Deerfoot Trail Study

Short-term Improvement
Options Stakeholder
Workshops
What We Heard Report
November / December
2016

Additional northbound exit lane on Deerfoot Trail at Heritage Meadows S.E.

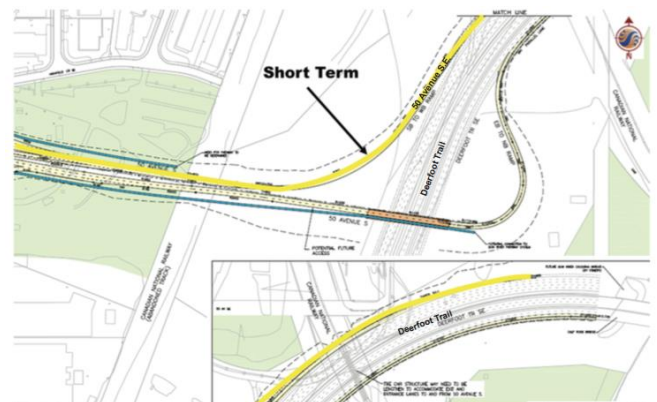
- Burdens local road network (i.e. Heritage Meadows and Heritage Drive S.E.)
- Existing queueing issues here that back up as far as Southland Drive S.E. – not sure this plan will resolve those issues

- Part of a larger collector-distributor system
- Protected “T” intersection
- Consider moving this off Deerfoot Trail completely and have it connect to 15 Street S.E.

Additional lane in both directions in the existing median from Memorial Drive to Beddington Trail N.E.

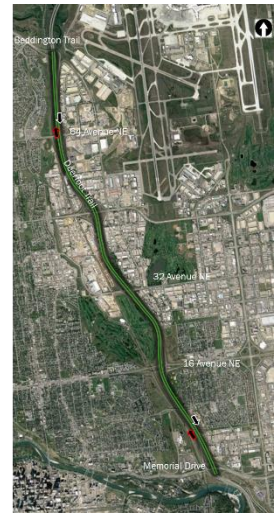
- If the median is removed, where will drainage go / how will this impact emergency response since many vehicles pull over to this area
- If high occupancy vehicle (HOV) lanes are implemented, they need to be enforced
- If high speed traffic keeps moving closer together and the median is removed, there is concern about an increase in collisions, especially in icy conditions
- Concerned HOV lanes won't work on Deerfoot Trail and will impede emergency responders' ability to access and respond to an incident
- Loss of the pedestrian bridge; would prefer to keep pedestrian/cycle connection

- Ensure there is still a shoulder to deal with incidents – some responders prefer to deal with incidents in the median shoulder, as opposed to the outside shoulder where traffic is merging
- Consider HOV lanes when adding lanes

Eliminate eastbound left turn at 32 Avenue N.E. / 12 Street N.E. and replace it with right turns

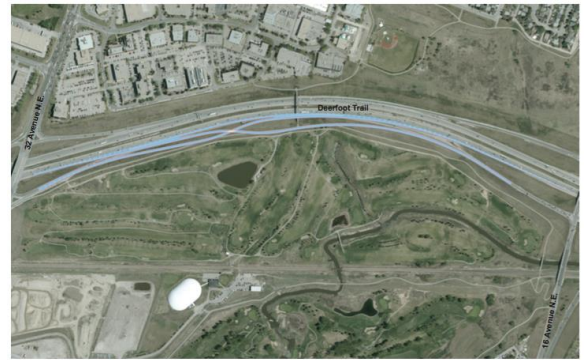
- This is already a congested area and drivers will have to go through intersection twice
- Safety concern with people having to cross the new road to access commercial buildings
- Too many left turns
- Driver education challenges

- Move it so it's not through the parking lot
- Roundabout
- May need a signal for drivers exiting the commercial area and turning left
